SUBJECT: Finding of No Significant Impact (FONSI) and
Final Environmental Assessment (FEA) for
Aliomanu Road Repair
TMK: 4-8-18: 028, 029, Anahola, Kauai

Final Environmental Assessment For 'Aliomanu Road Repair

Appendix A	Terrestrial and Aquatic Survey Report
Appendix B	Archaeological Assessment for the ‘Aliomanu Road Repair Project
Appendix C	‘Aliomanu Cultural Report
Appendix D	Geotechnical Report
Appendix E	Comment Letters and Responses

Figure 3-1. Plan and Profile of Road Repair and Rock Retention

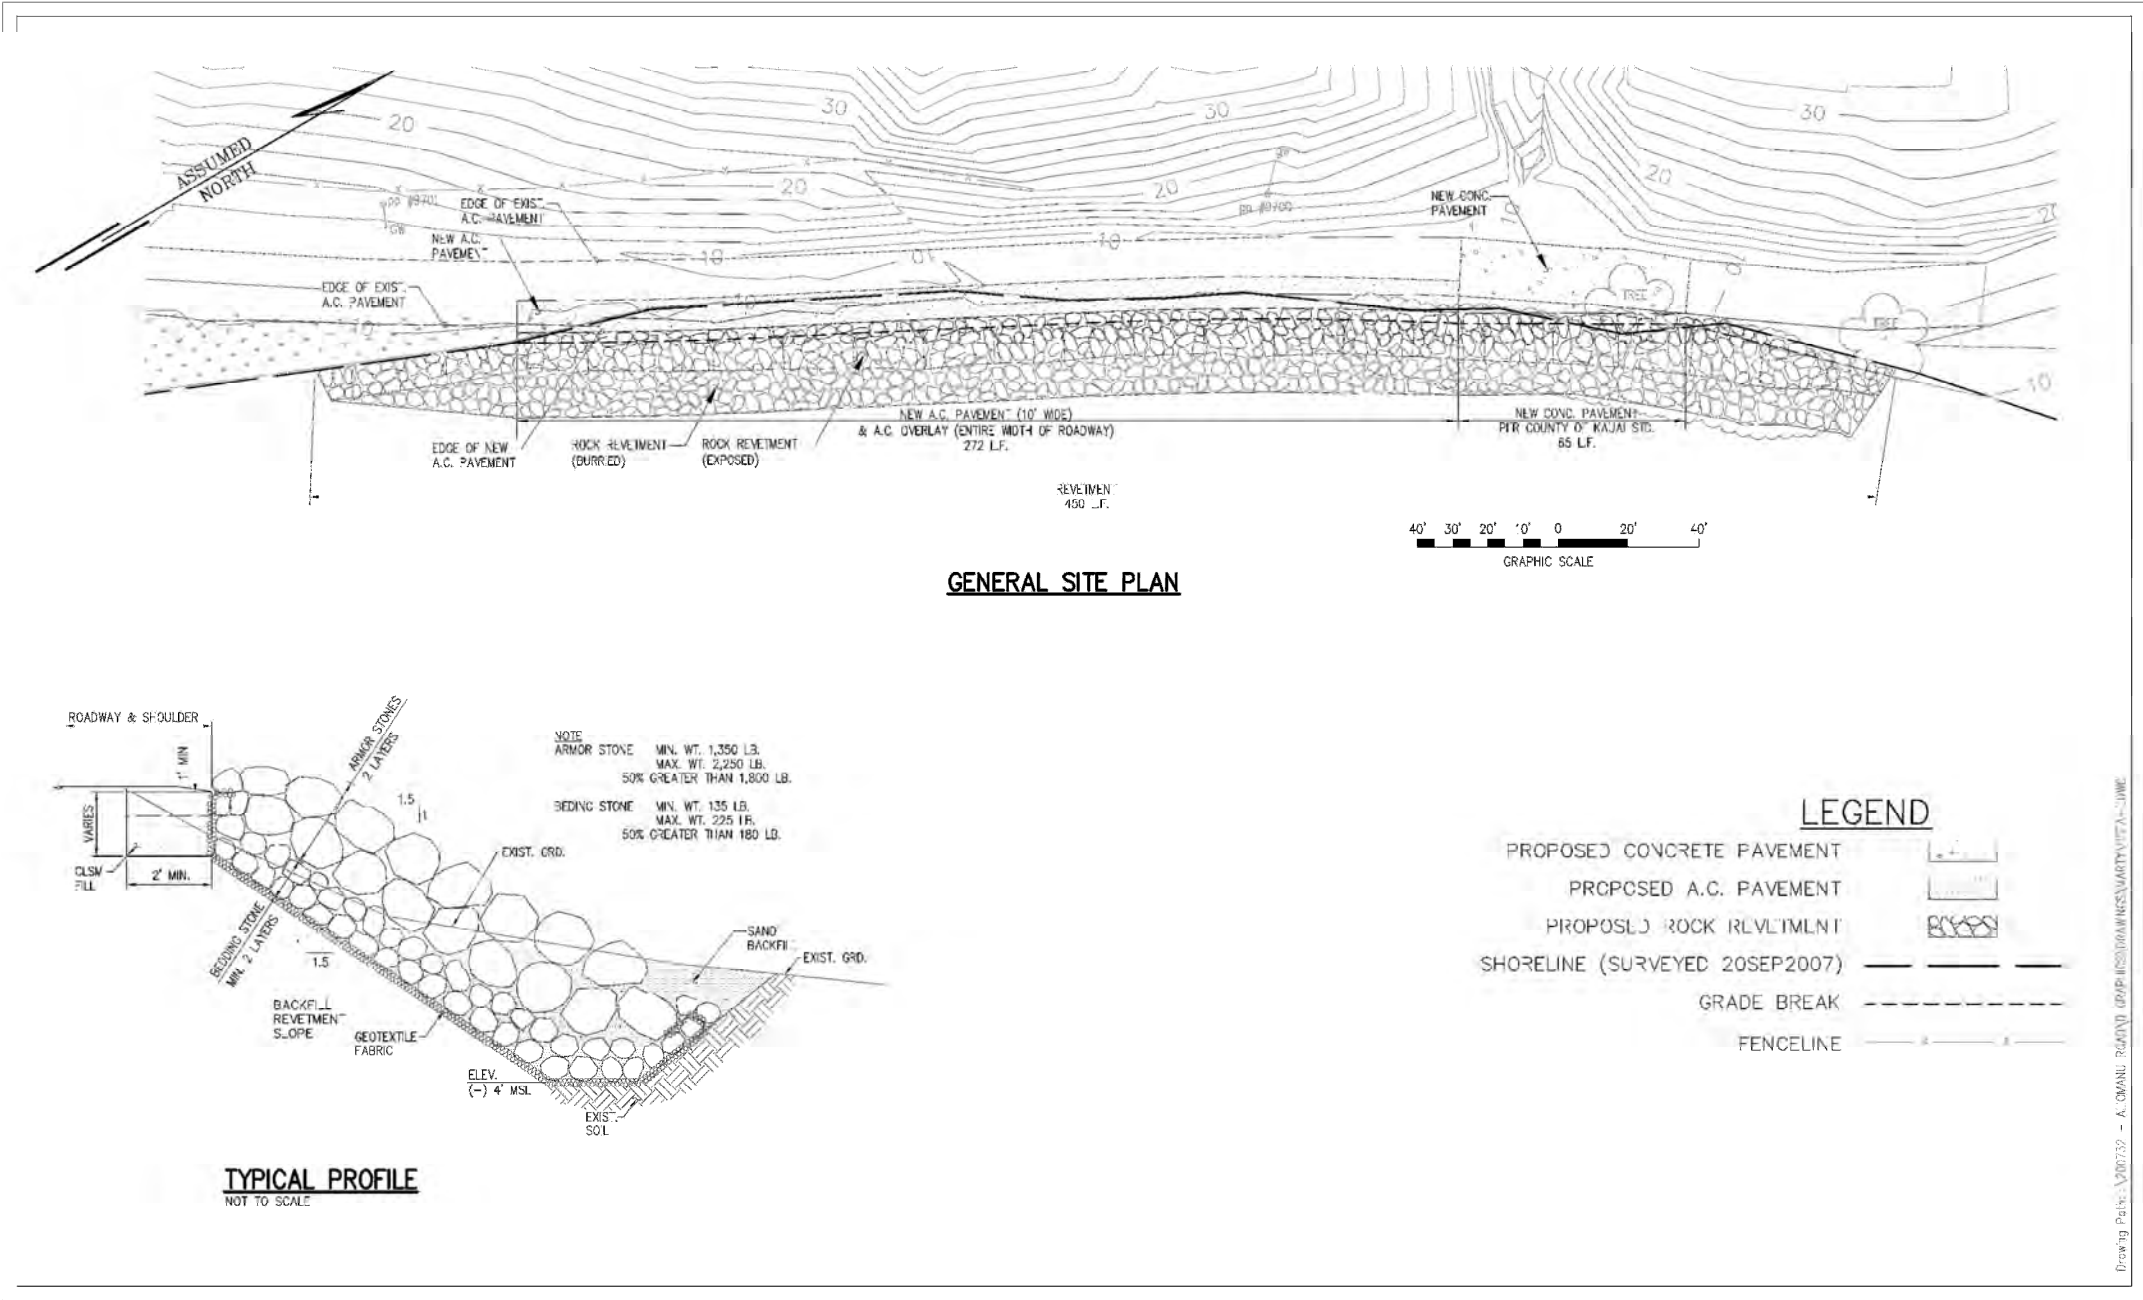
1. We recommend comments be solicited from the County's Flood Plain Manager.
2. Figure 3-1 Plan and Profile of Road Repair and Rock Revetment: The typical roadway section shows a 2 foot minimum shoulder width. The shoulder width is narrow and does not accommodate pedestrian traffic and presents traffic safety problems. We are also concerned with the roadway drainage. We believe the 2 foot shoulder width will serve as a bioretention area to accommodate the roadway drainage. We believe some of the storm flows from the roadway will percolate through the 2 foot strip and will be trapped between the geotextile fabric separating the rock revetment and filled section of the roadway repair and will further erode or undermine the roadway prism.

3. It appears the project area includes submerged lands seaward of the upper reach of the wash of the waves. The DEA should include a map depicting the high tide line and shoreline for reference in relation to the proposed actions. Please include a copy of a shoreline survey and include the shoreline on Figure 3.1 in the plan view and cross-section.

- 11. *Figure 3-1.* Please add the total structure length and the shoreline to the figure. Figure 3 of Appendix C Cultural Survey Report indicates a much larger project area.

- 12. *Figure 3-1.* Please provide the estimated structure height and width ranges (currently reads varies) to the figure. It is not clear from this figure how far seaward the proposed activities will extend.

- 13. *Figure 3-1.* Please describe the quantity and type of fill material to be used as backfill behind the revetment.
- 14. *Section 4. Physical, Biological and Cultural Environment.* Please add a coastal resource assessment. This section should include:

7. *Section 2.1 Project Description* – We will add the basic dimensions and a graphical scale into the plan and profile drawing (Figure 3-1).
8. *Section 3.2 Proposed Project Alternative* – Oceanit received a preliminary geotechnical report; however, the proposed revetment was not being considered at that time. The findings on soil type are valid, but the discussion on using the concrete retaining wall alternative is no longer applicable. We will add the preliminary report as an appendix to the FEA.

11. *Figure 3.1* – We will add a dimension to the figure for the 500-foot revetment length.
12. *Figure 3.1* – We added a graphical scale to the figure's plan view so that dimensions can be measured.

13. *Figure 3.1* - Fill material to build the revetment slope and road bed includes sand, rock, existing soil, and flowable fill (thin concrete). Total fill volume is approximately 2800 cubic yards.
